PROJECT: RENOVATIONS TO BUILDINGS S & V
ST. JOHNS RIVER STATE COLLEGE, ORANGE PARK CAMPUS

RENOVATIONS TO BUILDINGS S AND V, ORANGE PARK CAMPUS
ST. JOHNS RIVER STATE COLLEGE – BID-SJR-2011-07

Architects Job No. 015J03

ADDENDUM NO. 2

ESK 0.1-1	PROJECT TITLE: RENOVATION TO BUILDINGS S & V, ST. JOHN'S RIVER STATE COLLEGE	
	SHEET TITLE: SYMBOL LEGEND, FIXTURE SCHEDULE	
	DRAWN BY: LYW	CHECKED BY: RCC
	DATE: 11/21/11	2 ADDENDUM #2

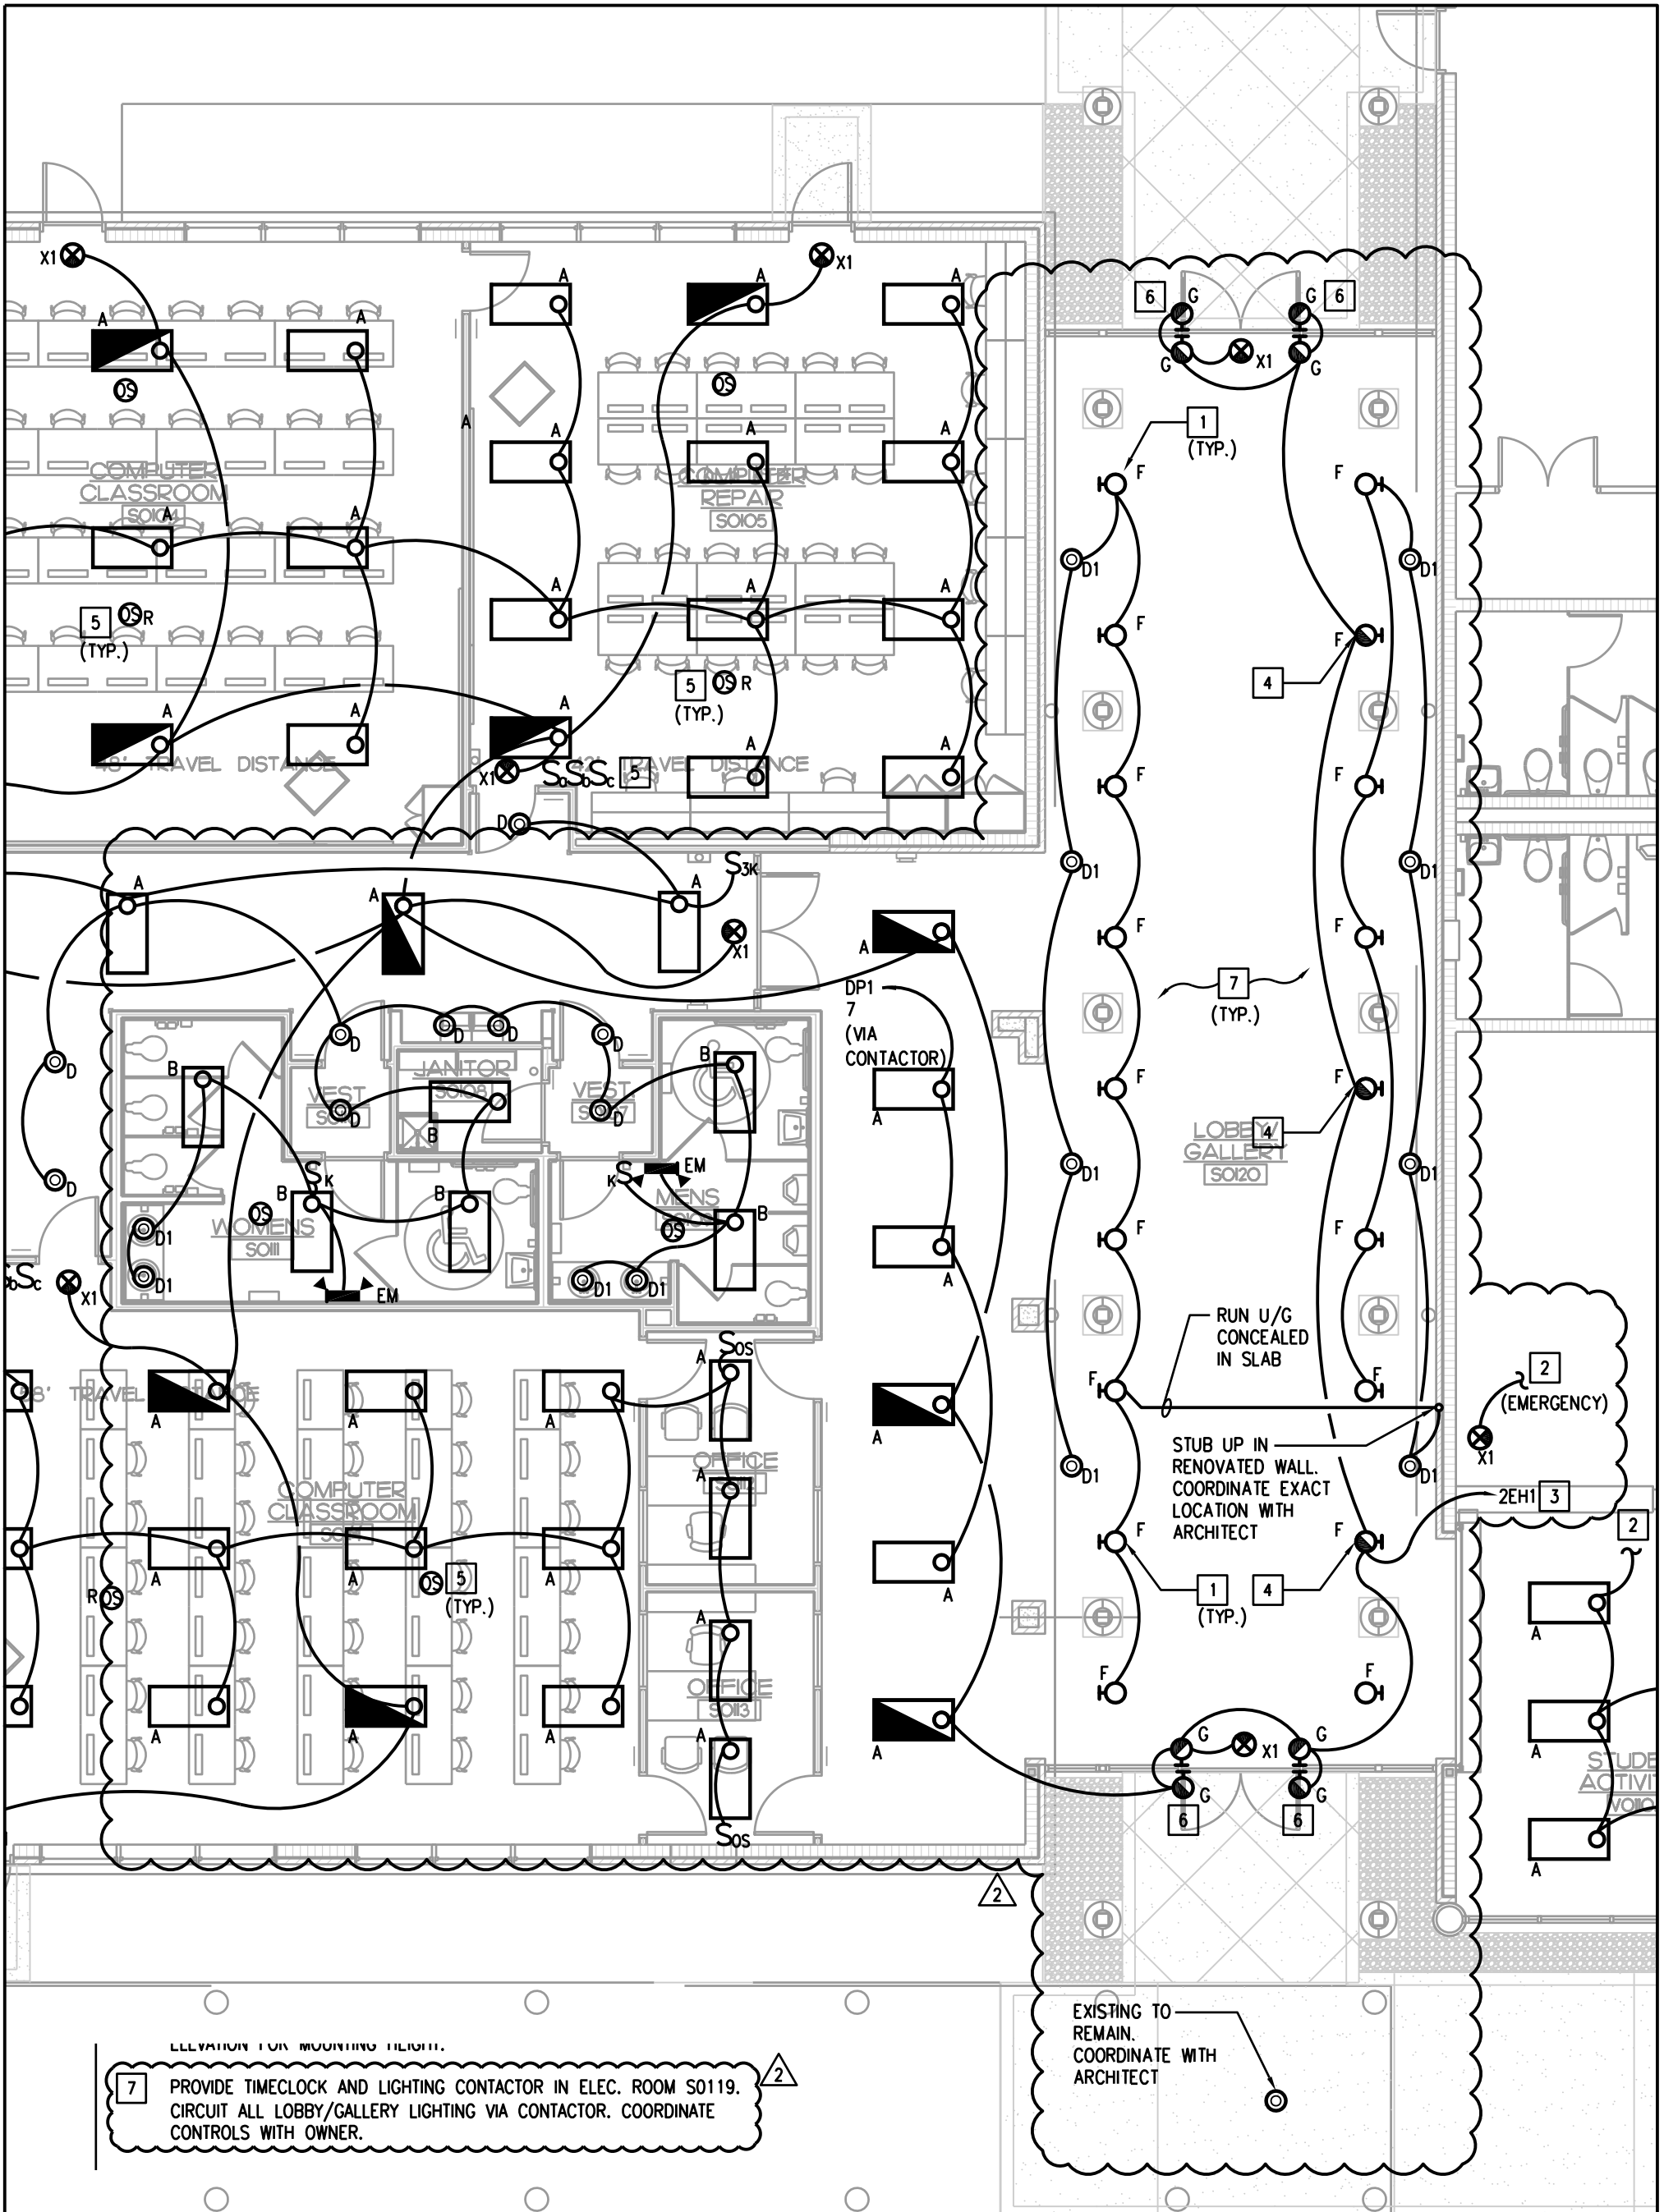
1. Refer to attached supplemental drawing ESK0.1-1: Added fixture types "D1" and "EM" to fixture schedule. Revised lamp wattage of fixture type "F".
2. Refer to attached supplemental drawing ESK1.1-1: Revised lighting quantity and locations to match Architectural RCP. Revised emergency circuiting. Added type "D1" downlights in restrooms. Added timeclock/lighting contactor for lobby area. Added exit sign in Building "V".

DRAWING NO.
**ESK
1.1-1**

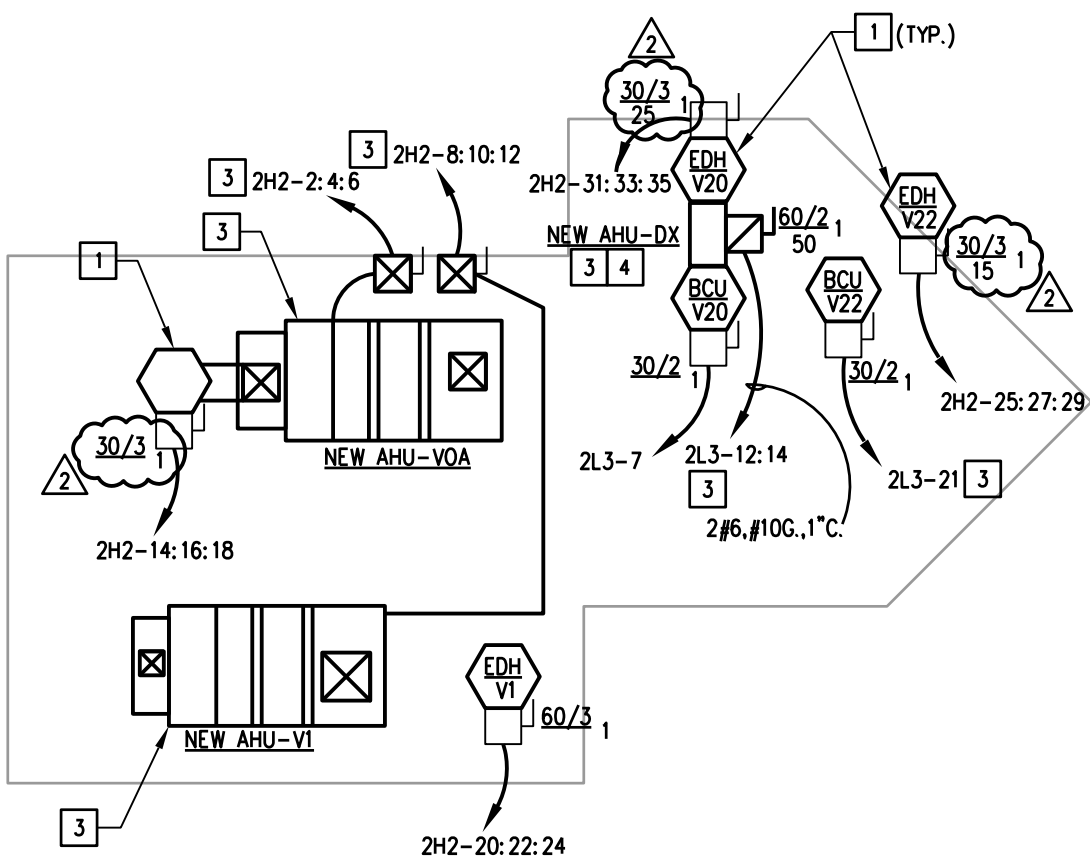
7 PROVIDE TIMECLOCK AND LIGHTING CONTACTOR IN ELEC. ROOM S0119. CIRCUIT ALL LOBBY/GALLERY LIGHTING VIA CONTACTOR. COORDINATE CONTROLS WITH OWNER.

ESK
 4.1-1

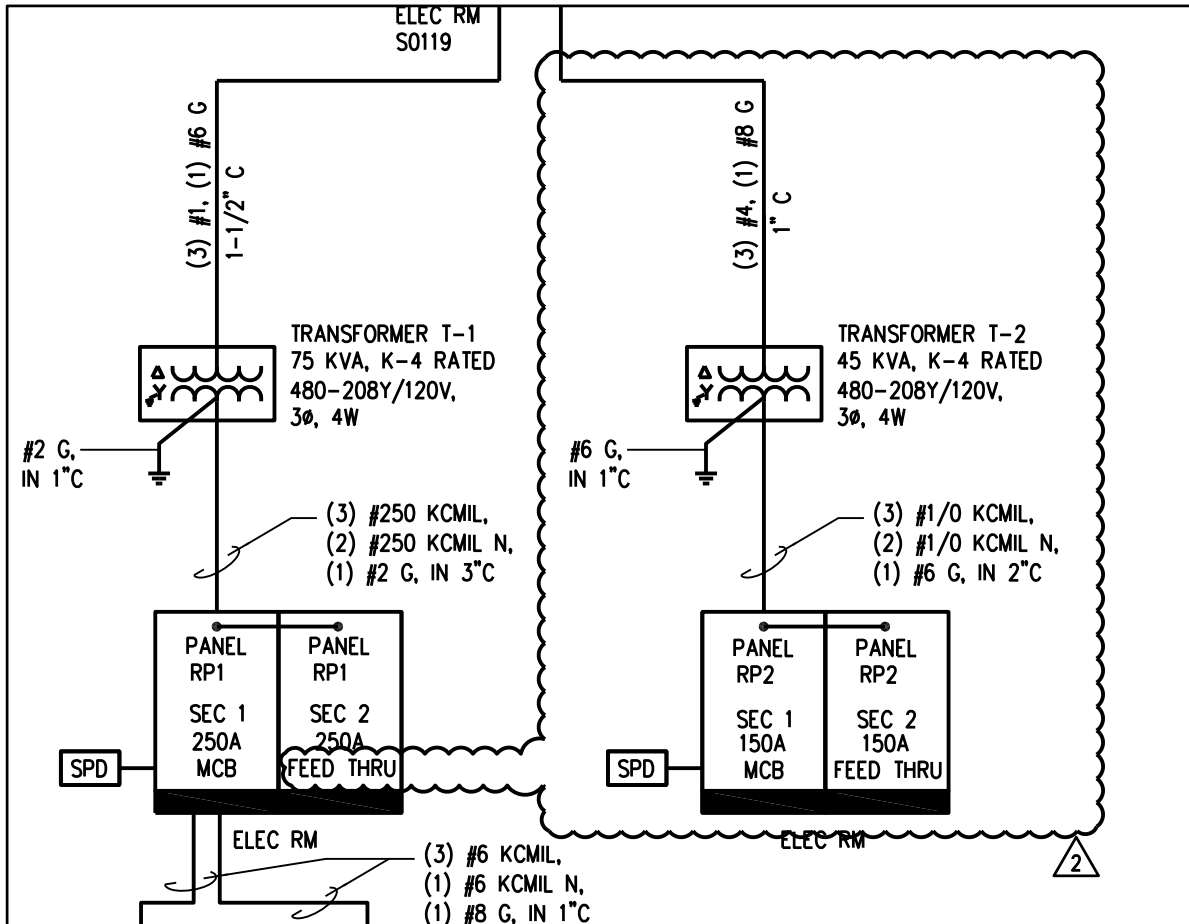
5. Refer to attached supplemental drawing ESK4.1-1: Revised Panel "2H2" electric duct heater loads and breakers to match HVAC revisions.
6. Refer to attached supplemental drawing ESK5.0-1: Revised Transformer T-2 to 45kVA. Revise Transformer primary, secondary feeder, and ground sizes accordingly. Revise Panel RP-1 and Panel RP-2 Section 2 to read "FEED THRU".
